# P802.3cn optical reflection limits (updated)

Pete Anslow, Ciena

IEEE P802.3cn Task Force, Long Beach, January 2019

# ER, ER4, ER8, 6 dB ER initial simulations

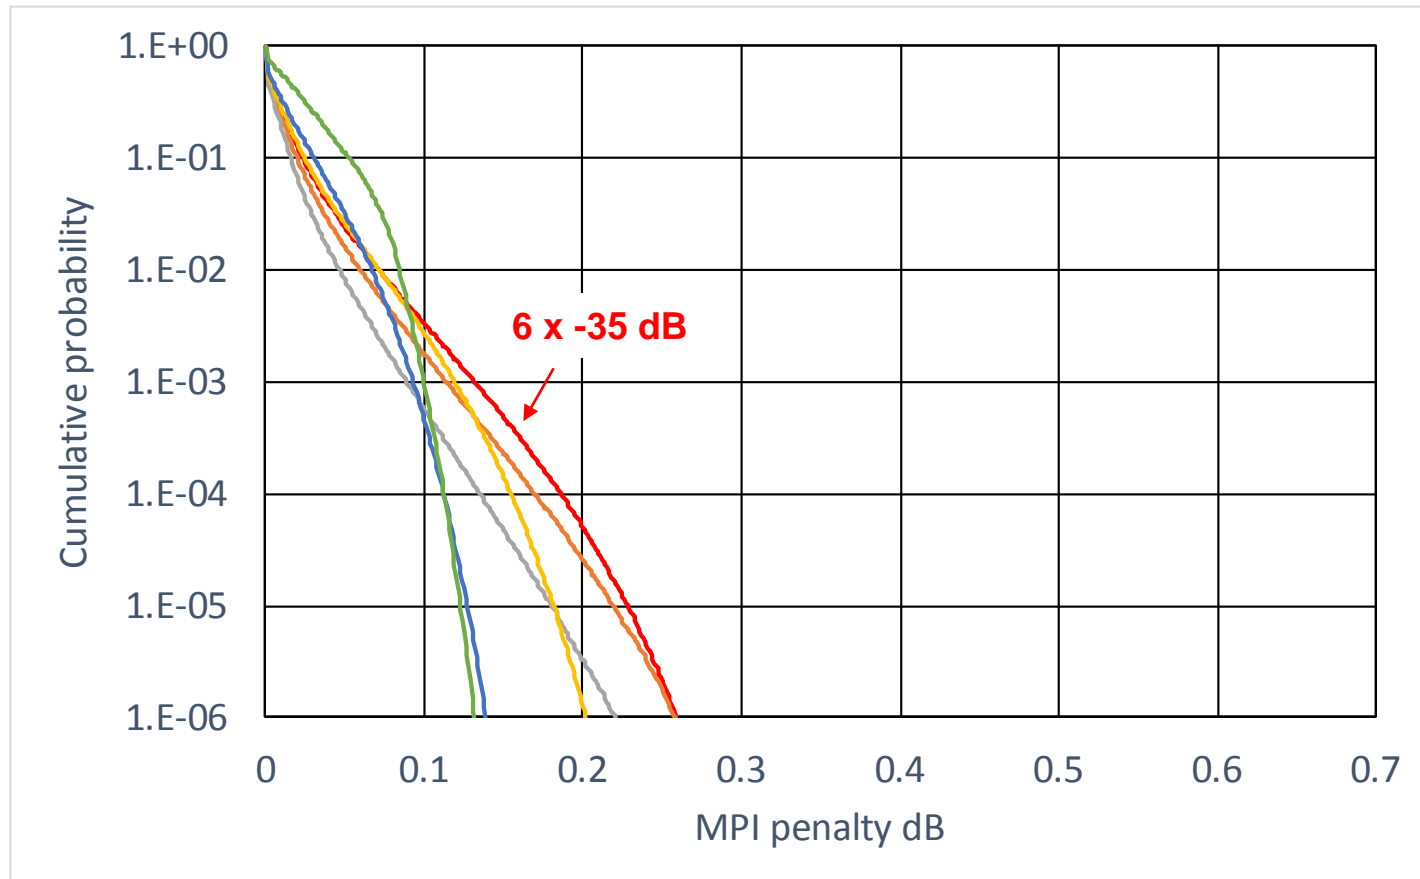
The initial values of the reflectances on page 3 are the same as those for 400GBASE-LR4 and the extinction ratio and channel loss values are taken from the baselines.

# ER, ER4, ER8, 6 dB ER updated simulations

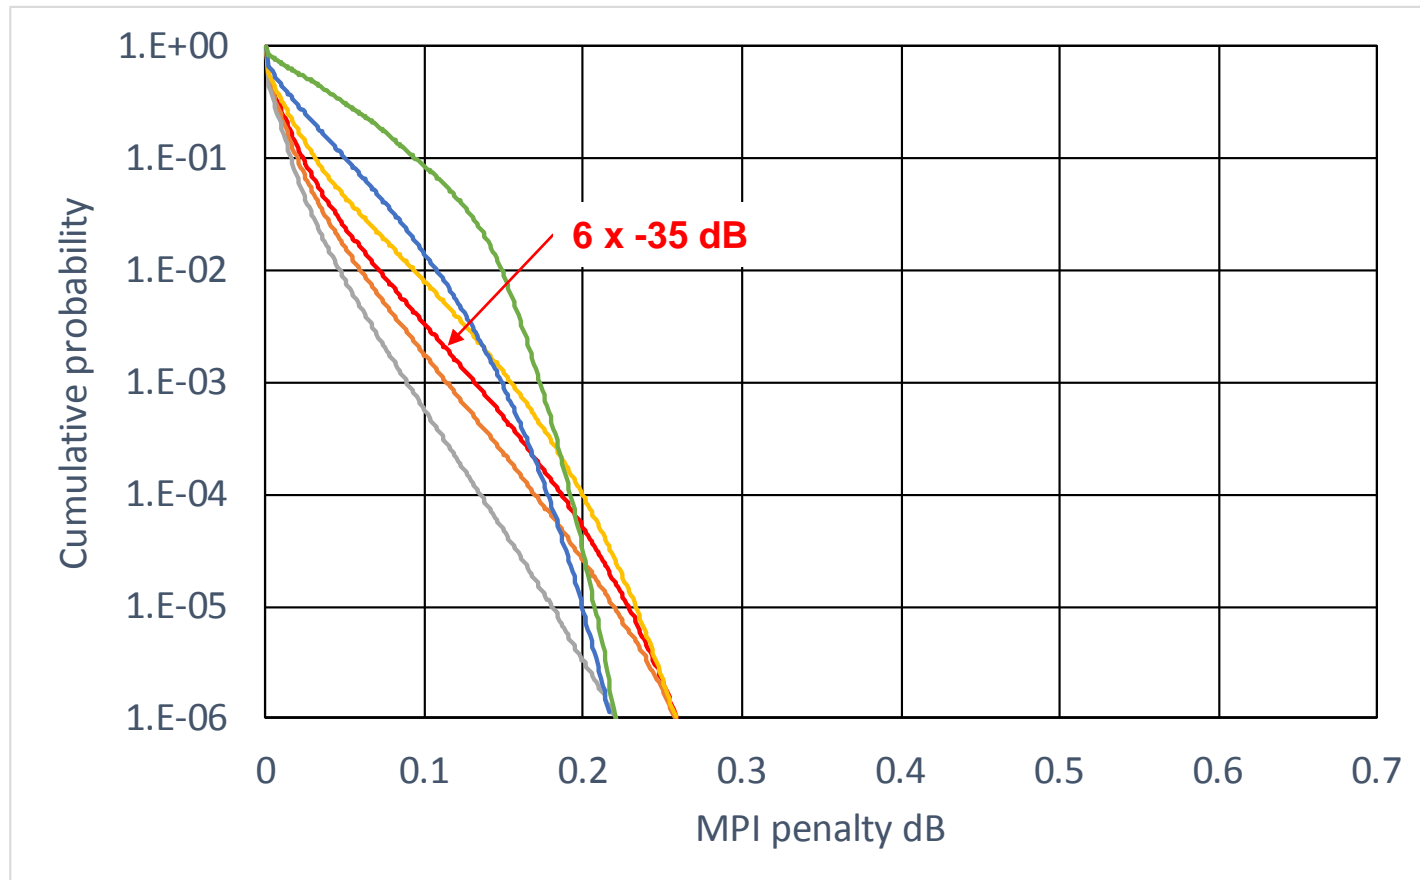
The results on page 4 are then re-calculated for the highest integer reflectance value for the penalty to remain below that for 6 x -35 dB.

Change the assumed values for the maximum discrete reflectance for 200GBASE-ER4 and 400GBASE-ER8 as shown below:

Change the assumed values for the maximum discrete reflectance for 50GBASE-ER as shown below:
